Application No.: 10/007,204
Amdt. Dated April 23, 2004
Reply to Office Action of November 25, 2003

Application No.: 10/007/204
Amdt. Dated April 23, 2004
Reply to Office Action of November 25, 2003
Annotaed Sheet Showing Changes

FIG. 3A

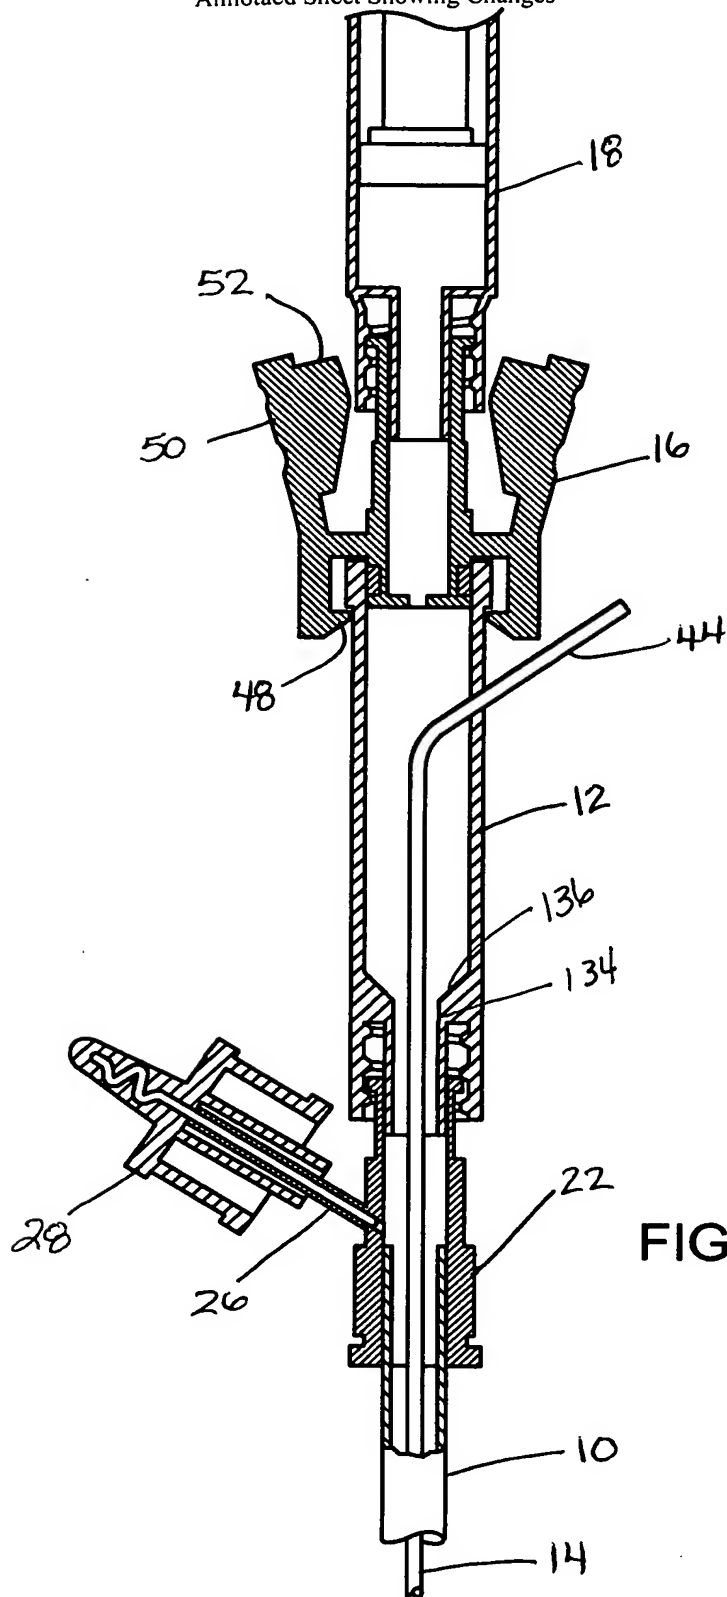
The proposed drawing correction filed on June 9, 2003 was not approved. Specifically, the office action states that the "drawings are objected to under 37 CFR 1.83(a). The drawings must show every feature of the invention specified in the claims. Therefore, the features of claims 5 and 6, wherein the hydration chamber has a tapered portion in between two larger portions, must be shown or the feature(s) canceled from the claim(s). No new matter should be entered. Since this subject matter is described in the original disclosure, applicant may submit drawings showing this feature." This objection is respectfully traversed.

Figs. 3A, 3B, 3C, and 3D have been amended to include the features of Claims 5 and 6. However, it is pointed out that these features are also included in other figures such as Fig. 6, among others.

Thus, it is respectfully requested that this objection be withdrawn and the amendments to Figs. 11 and 3A-3D be approved and entered.
